YEAR  
1994

MODEL  
LEGEND

BULLETIN NO.  
95-003

## Cruise Control Will Not Engage

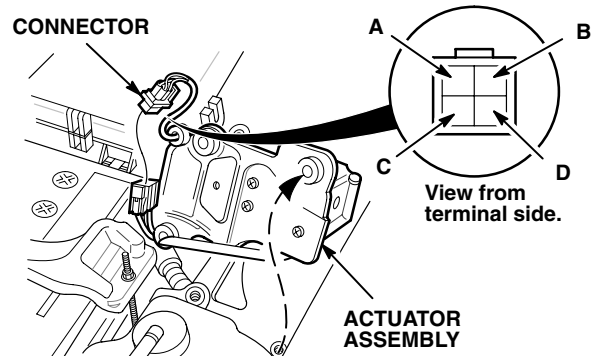
3. Remove the cruise control actuator assembly (three 6 mm bolts), then roll the actuator on its side to access and disconnect the 4-P connector.

NOTE: Handle the cruise control actuator assembly carefully; excessive jarring may temporarily correct the symptom, leading to an incorrect resistance value.

4. Measure the resistance between terminals B and C of the cruise control actuator connector.
  - If the resistance is less than 50 ohms, replace the cruise control actuator assembly (see PARTS INFORMATION).
  - If the resistance is more than 50 ohms, perform the input test in section 23 of the Service Manual. Be sure to correct the input test procedure as shown on page 2 of this service bulletin.
